Detailed Site Plan
Alternative Compliance
Dobson Ridge

DSP-20007
AC-21009

SUBJECT: Detailed Site Plan DSP-20007
Type 2 Tree Conservation Plan TCP2-013-2021
Alternative Compliance AC-21009
Dobson Ridge

Figure 4: Sign Elevations

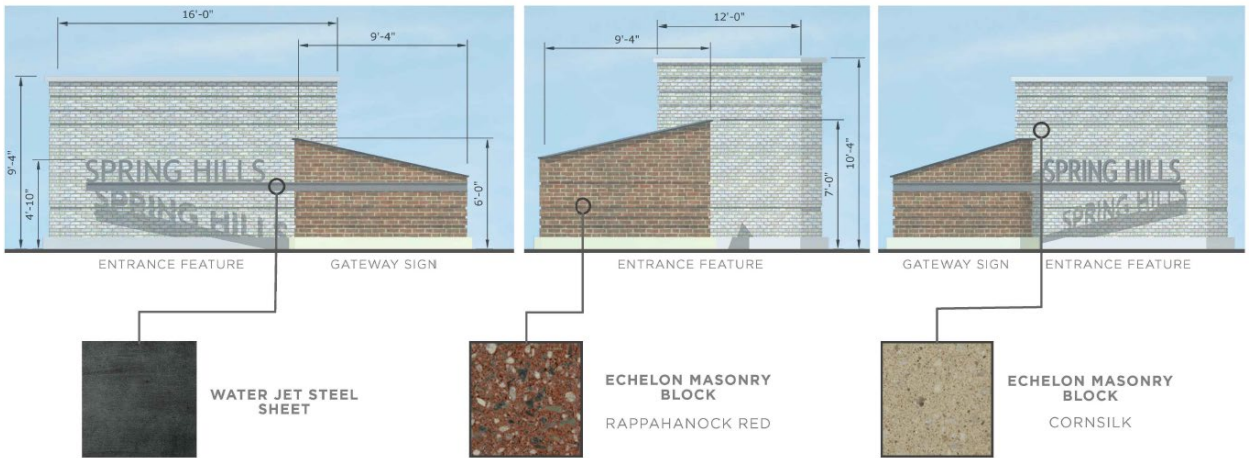
It is unclear if the signs are illuminated, and staff recommends this information be shown, as conditioned herein. In addition, it is also recommended that if the sign is illuminated the lighting not cast glare onto the roadway or residential lots.

- r. Indicate if the gateway sign is illuminated and provide the applicable details.
- s. Provide a brick tracking chart to ensure a minimum of 60 percent of all townhouse units have a full front facade (excluding gables, bay windows, trim, and doors) of brick, stone, or stucco.
